**Subject: Smoky Canyon Mine Remedial Investigation/Feasibility Study (RI/FS)
Simplot Responses to Agency Comments on
Draft Phase 2 Pilot Study Work Plan and Sampling and Analysis Plan
Ultra-Filtration/Reverse Osmosis and Biological Selenium Removal Fluidized Bed
Bioreactor Treatment Technology**

**Simplot Responses to Agency Comments (January 3, 2017) and
Additional Comments (January 13, 2017) on the
“Draft Phase 2 Pilot Study Work Plan and Sampling and Analysis Plan
Ultra-Filtration/Reverse Osmosis and Biological Selenium Removal Fluidized Bed
Bioreactor Treatment Technology” (October 2016)**

Fig. 4. Eh-pH diagram for part of the system Se-O-H.
The activity of dissolved Se = 10^{-4} . See text for discussion.

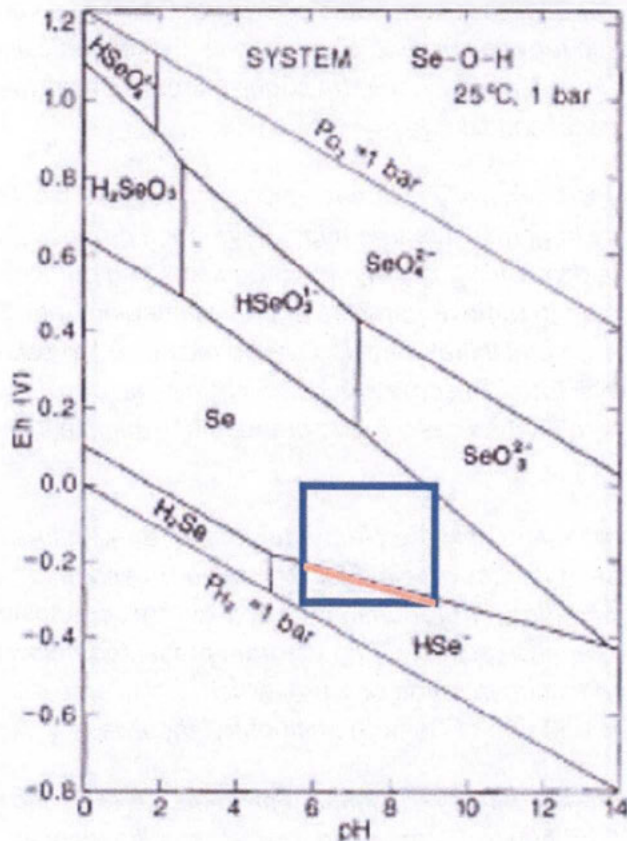
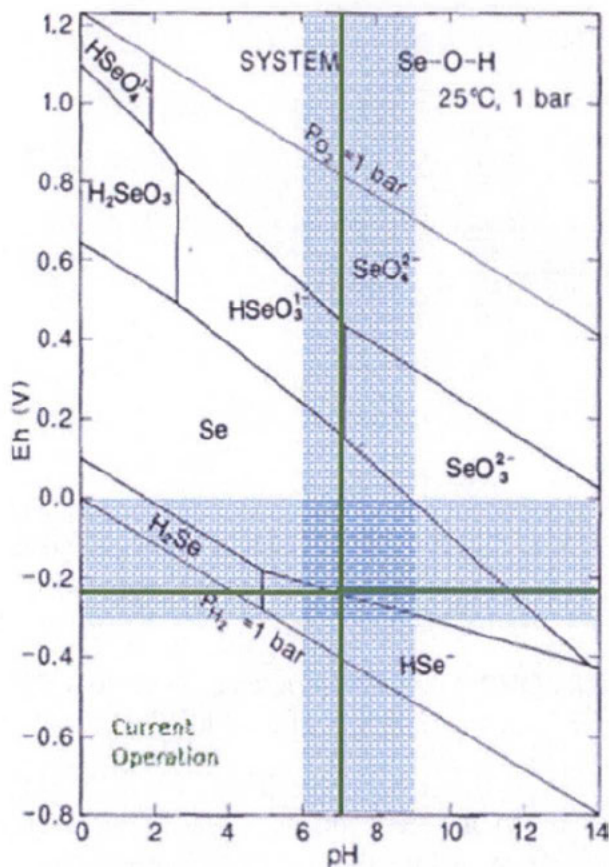
SC-18 Section 3.3, Page 30, Pilot Unit Operation, first paragraph. While FBR treatment for Se has been gaining acceptance through observed effectiveness at various mining sites, there are some inherent challenges: 1) the potential release of particulate elemental Se in the treated water; 2) kinetics; 3) maintaining redox and pH conditions that are conducive to formation of elemental Se rather than soluble forms of Se; 4) maintaining the active, biological communities in the reactor; and 5) being able to mechanically keep the bed in a fluidized state. Therefore, Simplot should be cognizant of how well the process can maintain stability in upset conditions. *- EPA*

Post-treatment of effluent from a FBR generally includes aeration to remove biochemical oxygen demand (BOD) and any hydrogen sulfide that might have been produced, as well as addition of a flocculent to aid in settling out of microorganisms and particulates and a subsequent sand filtration step to remove particles. If particulate elemental Se is present in the effluent, there is the potential that particles will be reoxidized to selenite and/or selenate, both of which are soluble. In some studies, therefore, an additional filtration step conducted prior to aeration has been recommended to minimize this potential.

Selenium chemistry is redox sensitive and only the elemental form of Se is insoluble. A predominance diagram (Reference 1) is shown below for the stable Eh and pH zones for various inorganic Se species. Boundaries for predominance zones vary depending on temperature and concentration (or analyte activity). The diagram presented below is for a system at room temperature and a concentration of 1 μ M, which is similar to the average concentration (125 μ g/l = 1.58 μ M) of Se in the influent of the Phase 1 pilot.

The blue box represents the region captured by the influent pH range (6 to 9) and the stated desired ORP range of -200 to -500 mV (converted to Eh assuming a conversion factor of +200 mV – see next paragraph). The orange diagonal line is the boundary between elemental Se, which is insoluble, and hydrogen selenide [Se(II)], which is soluble. Although it may be re-oxidized to elemental Se in the post-FBR treatment step and be sequestered during flocculation, any HSe⁻ formed may travel through the post-treatment system in the dissolved phase to oxidize downstream. It is recommended that the Eh zone above the orange line be targeted for most effective removal of Se within the FBR system as elemental Se.

Eh is the redox potential normalized to the hydrogen electrode and is the value used for direct comparison to tabulated values in redox tables for reactions. The factor used to convert measured ORP vales to *Eh* vary depending on the filling solution of the particular probe used. The below table (Reference 2) provides values for several filling solutions and the conversion factors based on temperature. It is recommended that *Eh* values be reported alongside ORP values, or at least that temperature and the type of filling solution are provided for later calculation.

Response: Pourbaix diagrams are used as a guideline to define target ORP conditions in our system. As these are somewhat theoretical, and do not cover all water chemistry conditions encountered in the field, our approach is to correlate the actual ORP and pH of the effluent with removal efficiencies to achieve maximum removal.

A couple of points in regards to the bioreactor ORP: 1) the FBR operates similar to a plug flow reactor and is not well mixed, and (2) the ORP measurement is taken at the (bulk liquid) effluent from the second stage.

In order to ensure that throughout the entire depth of the second stage reactor operation takes place in the zone where oxidized species (selenate, selenite) are reduced to elemental selenium, we target the low end of the ORP range at the second stage effluent measurement point. This will ensure that we are in the conditions in which elemental selenium is the predominant equilibrium species throughout most of the bioreactor bed. The Work Plan/SAP cites an ORP range of -200 to -500mV to cover the entire span of operating pHs (6-9) that might be encountered during operations. During Phase 1, operation has been at a pH of approximately 7 and an effluent ORP slightly below -400 mV. This puts us at the target discharge ORP from the second stage as shown below on the Eh-pH diagram, for example.

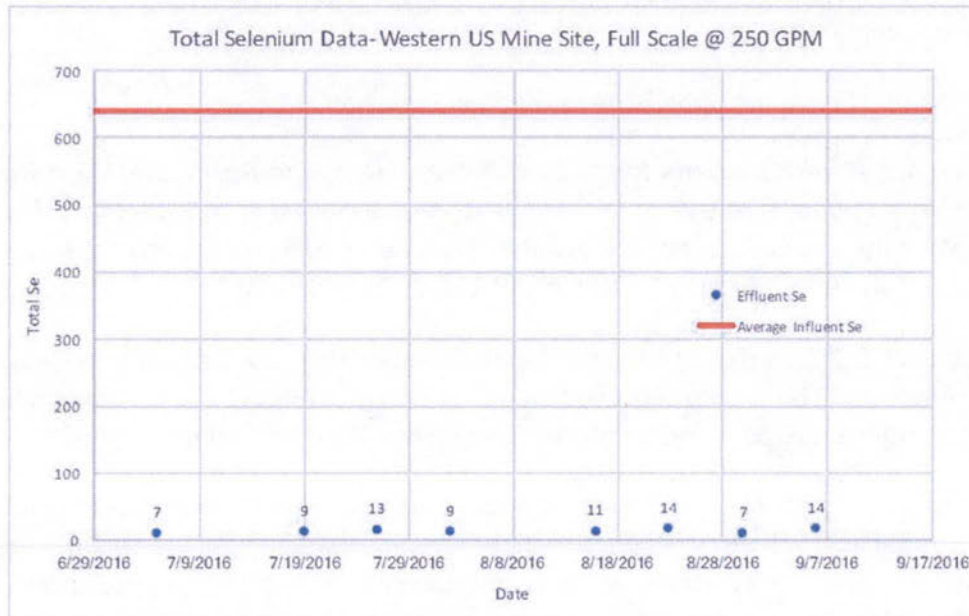
SC-22 Section 3.3.2, Page 32, Pilot Unit Monitoring, Table 3-8. *Please define Influent and Effluent. At first glance, these might mean FBR influent and effluent, since that is the primary Se removal process. From later context, it became clear that these are total*

system influent and effluent, where influent is raw water (UF influent) and effluent is either sand filter effluent or final system effluent after re-blending filter effluent with bypassed water (please clarify). Seems like monitoring at multiple locations (e.g., similar to those indicated in Table 3-8 for the one-time initial startup sample) on a regular basis throughout the study, would be warranted, to allow evaluation of the performance and operation adjustment/optimization/troubleshooting of the different unit processes in the treatment train. Selected key parameters pertinent to each unit process would be sufficient. For example, do you need to know FBR influent Se and FBR effluent Se, BOD, N, P, and sulfide (in addition to pH, DO, and ORP determined by inline meters) to help optimize operation and chemical feed rates? Another example is that it would be difficult to determine and adjust activated sludge SRT without knowing the solids concentration in the aeration basins and RAS (clarifier underflow).

EPA
SC-23 Section 3.3.2, Page 32, Pilot Unit Monitoring, Table 3-8, RO concentrate. The primary purpose of the two FBR units in the Phase 2 Pilot is to remove Se from the concentrate (or reject) stream of the RO unit. It is stated that the solutes will be concentrated by 4 times in that water. With an average influent concentration of 125 µg/l, the water to be treated in each FBR would be anticipated to have an average of 500 µg/l (and if maximum is 140 µg/l, there could be a maximum of 560 µg/l). EPA is unaware of prior studies demonstrating removal of such high concentrations within FBR systems, and thus it may not be possible to reduce levels to the water quality criterion. However, the effluent from the FBR post-treatment will be diluted by water having little to no Se (RO clean water stream) prior to being discharged at the outfall, so the final water may meet the criterion.

Sampling locations noted in Table 3-8 indicate that influent and effluent are to be sampled weekly, but that the effluent from the FBRs are going to be sampled only on week zero and at shut-down. The location of the effluent sampling is not clear, but this reviewer assumes that it is after the mixing of the water sources and prior to discharge at the outfall. It is recommended that effluent from the FBRs be sampled at a few of the weekly sampling events across the entire period of the pilot to understand the potential source of Se that was observed in the Phase I final effluent. Modifications to the design based on those findings could allow the system effluent to consistently meet WQC (and address Decision Input 2). Additionally, sampling would allow a better understanding of the actual removal attainable by the FBR system given that the Phase 2 pilot will have a much higher influent concentration than did the Phase 1 Pilot or other studies with which we are familiar.

Response: Please refer to the response to SC-21. Extensive operational monitoring will be occurring at the water treatment plant; however, the scope of the reported data will be limited to the overall system performance (influent vs. effluent), for the parameters defined in Table 3-8.

Response: Shown below is a depiction of full-scale data from a western U.S. mine site

that utilizes the same Frontier Model unit that is being utilized at the Smoky Canyon Mine site. As shown, the FBR unit is receiving 250 gpm of influent water at concentrations over 600 $\mu\text{g/L}$ and decreasing concentrations to less than 14 $\mu\text{g/L}$.

As recommended, additional sampling locations have been added to the monitoring program under this Work Plan/SAP, as shown in revised Table 3-8.
